STAFF RECOMMENDATION

945 S Douglas Avenue, Unit #3

February 17, 2021

Application: New Construction – Infill/Part II SP

Figure 5. Roof plan

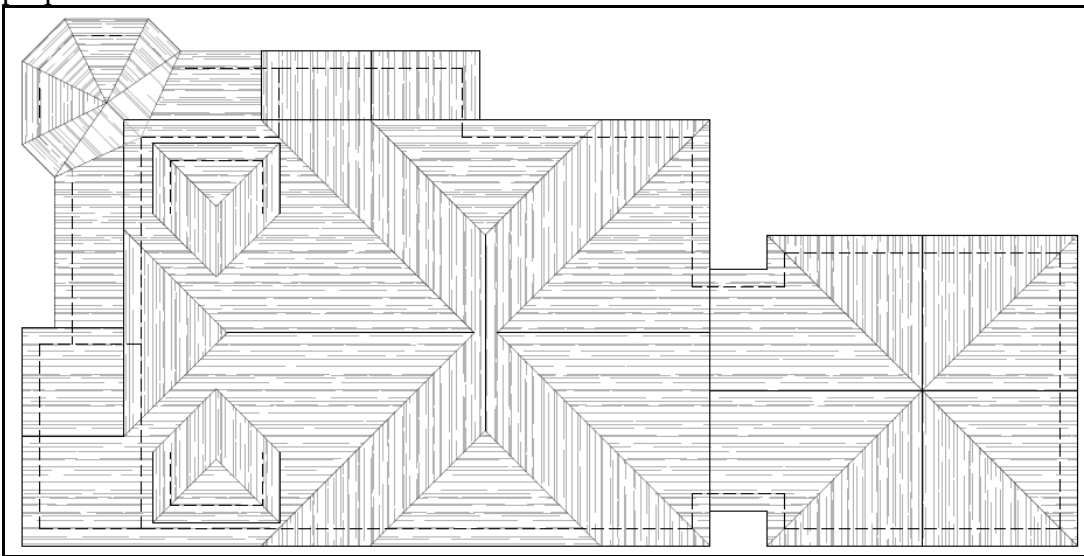
Roof Shape: The main roof form is a clipped cross gable with a 10 /12 slope, which is appropriate. The applicant was encouraged to pursue different designs for the individual units rather than design them all the same and that is accomplished with the first three proposals.

The design uses a dormer on both side elevations, in front of the main side gable. (Figures 3 & 4) These dormers are appropriately scaled and located and they are inset two feet (2') from the wall below, as per the design guidelines. The wrap-around porch has a shed roof and octagonal corner feature with a conical roof.

Staff finds that the proposal meets section III.E for roof shape.

Figure 7. Massing study from Part I SP application

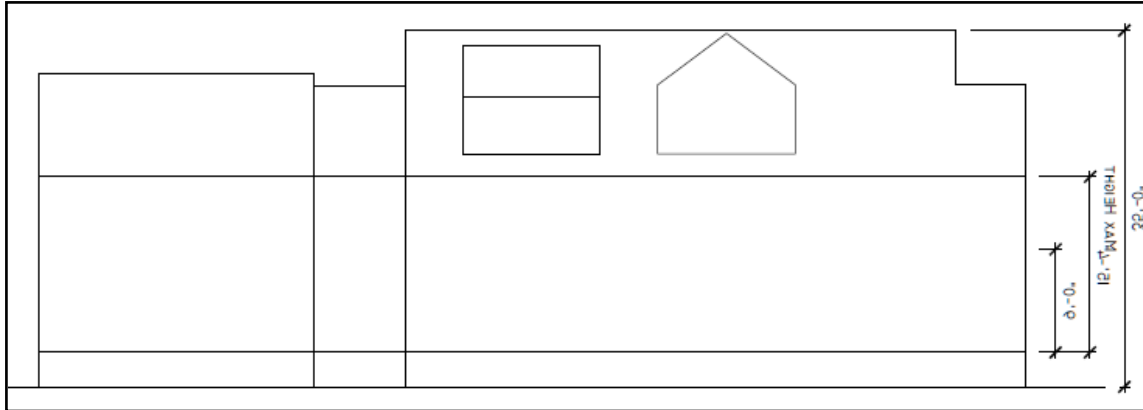
Outbuildings: As per the approved SP, all nineteen (19) of the houses in this project will include an attached garage accessed off of the rear private drive. The massing studies from the part I SP application show the attached garages for the thirty-five foot (35') tall one-and-a-half story units #1-#7 as subservient in height with a ridge height of approximately twenty-seven feet (27') from grade and an eave of fifteen feet, four inches (15'4") from foundation. (Figure 7) The Commission approved Unit #3 to have a one-and-a-half-story form, with a thirty-two foot (32') ridge and twelve foot (12') eave, something not proposed in the Part I SP. No specific mention was made of adjustments to the garage massing.

The proposed attached garage has a ridge height of about twenty-four feet (24') from grade and an eave of about twelve feet (12'). Staff finds that the proposed massing, which keeps the garage and connector lower and subservient, while matching the approved eave height of the house, is consistent with the SP approval.

Staff finds that the proposed attached garage is consistent with the massing and site plan of the approved SP.

SP SITE PLAN

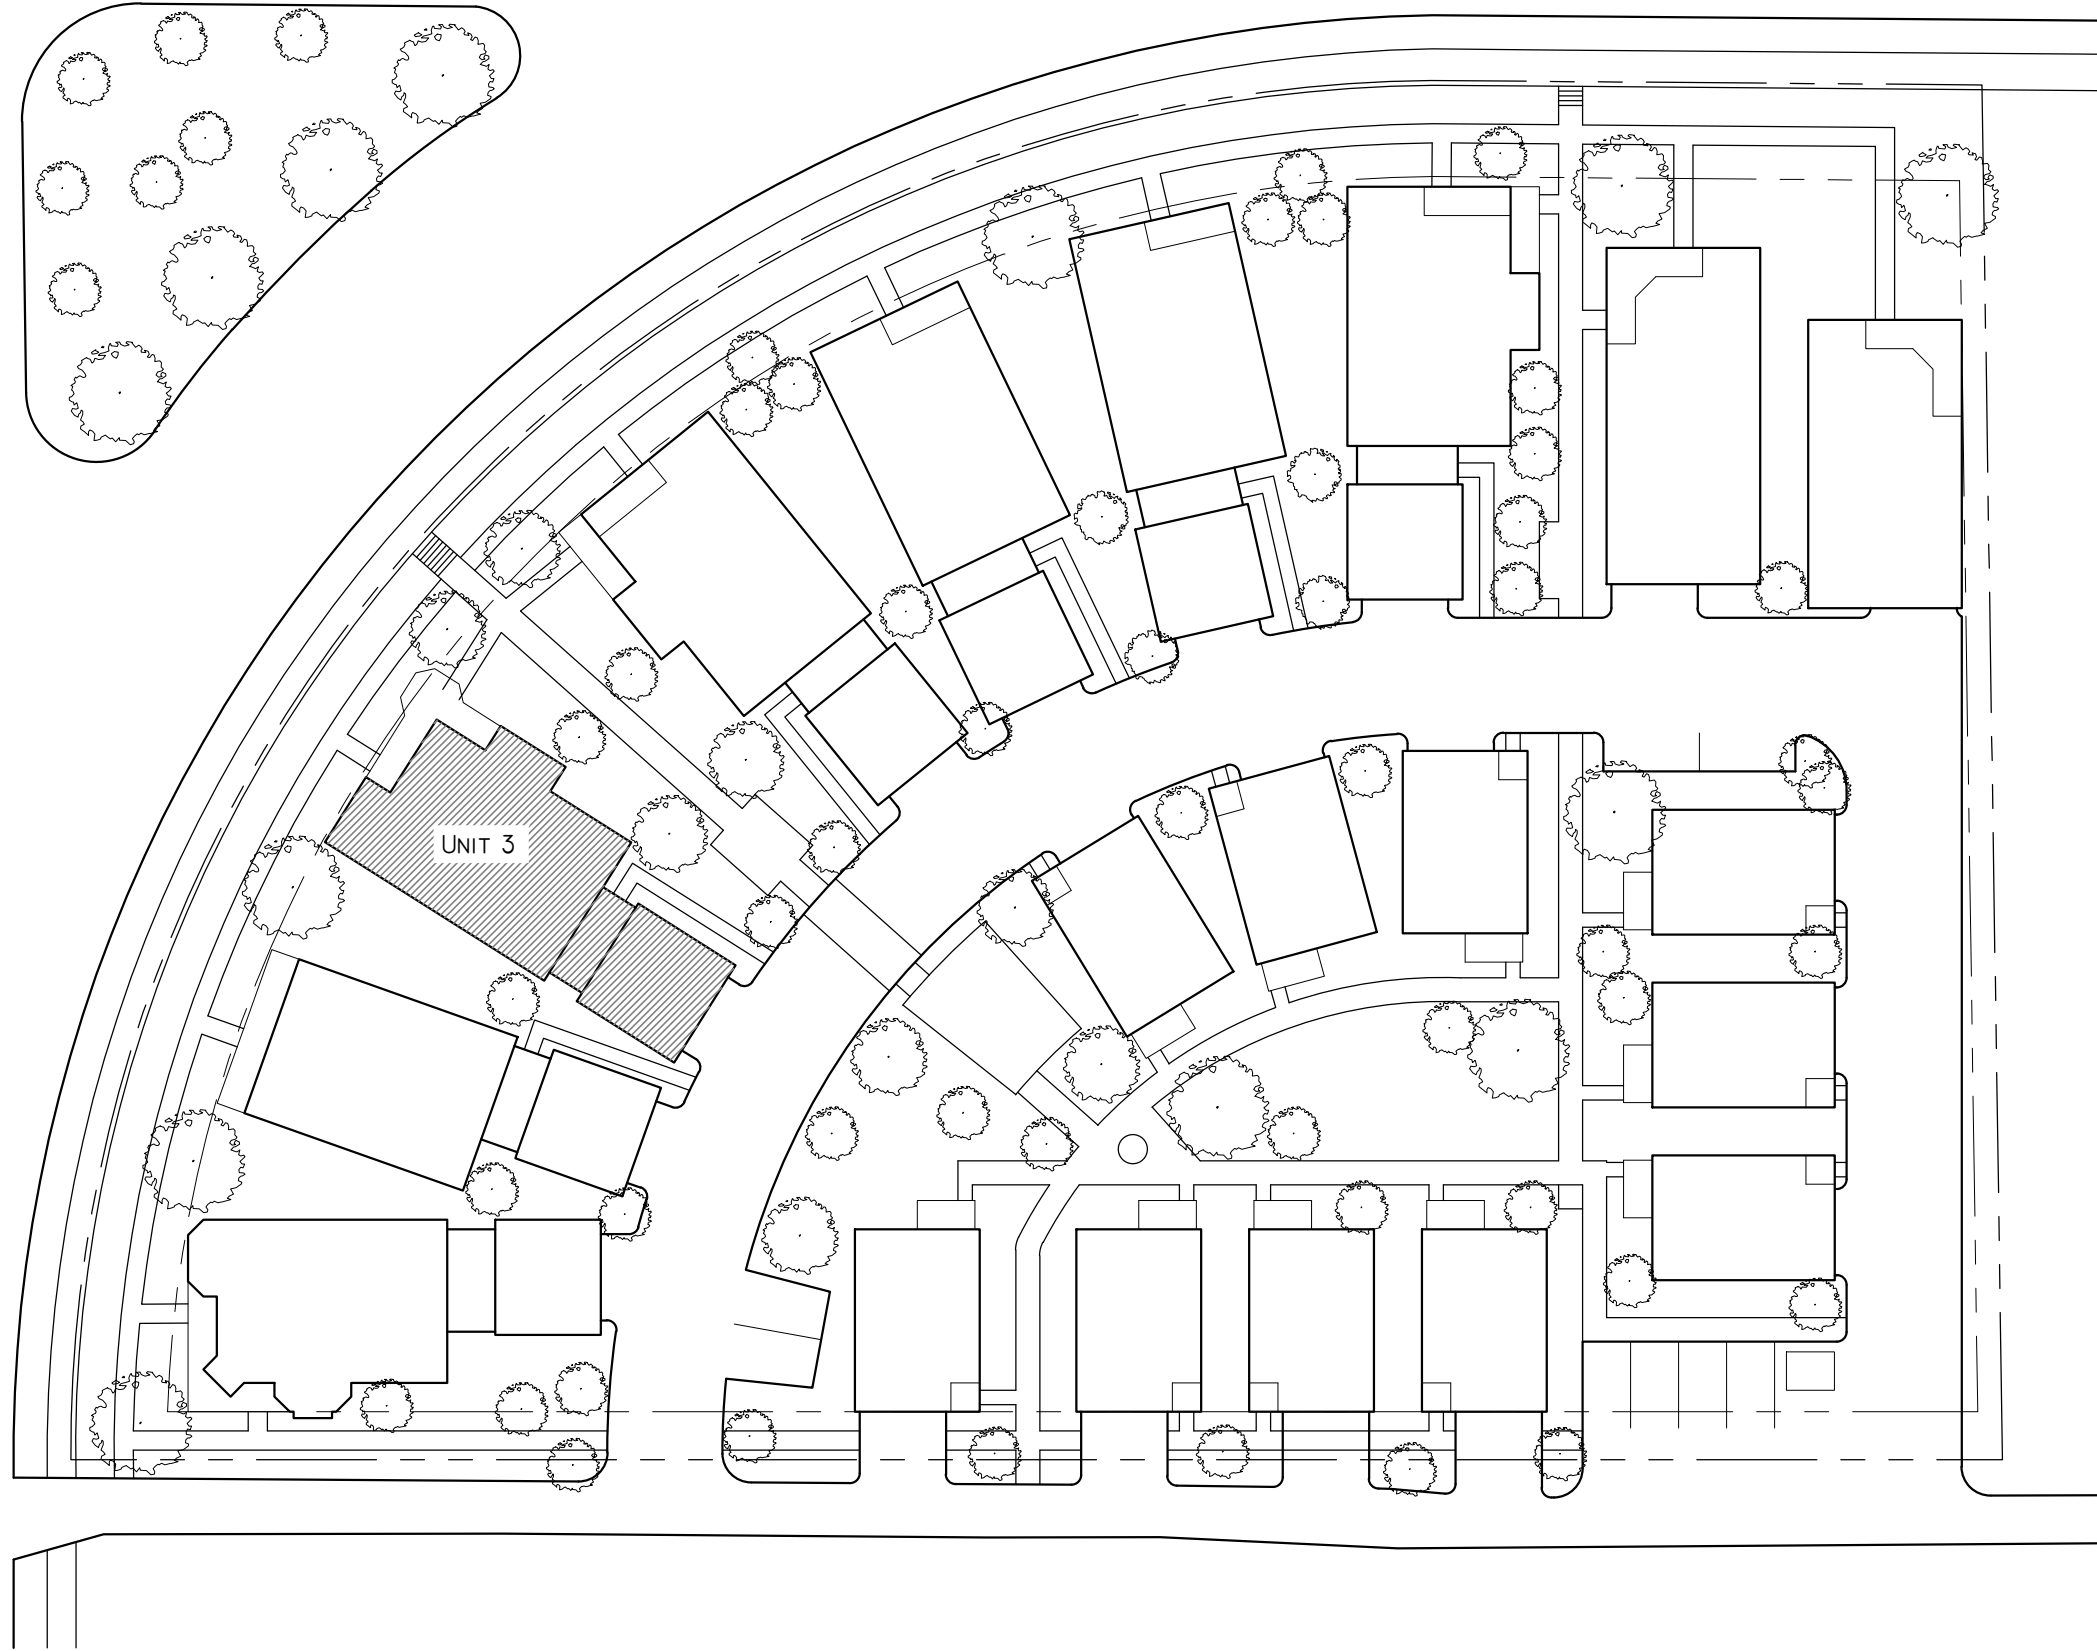
Setback & Rhythm of Spacing: The infill will be sited as per the approved part I SP. (Figure 1) This house will have a twenty-foot (20') front setback, as do all of Units 1-7. These houses will mostly be about twenty-five feet (25') apart at the front and will come closer further back, due to the curve of the parcel. Most will still maintain a minimum distance of about ten feet (10').

Units #2 and #3 maintain this twenty-five foot (25') distance at the front, while the back corners are about thirteen feet (13') apart. A pedestrian walkway is planned between Units #3 and #4, so these two units are further apart than the others. They will be about thirty-five feet (35') apart at the front and thirty feet (30') apart at their closest point.

The project meets the SP approval and section III.C for setback and rhythm of spacing for new construction.
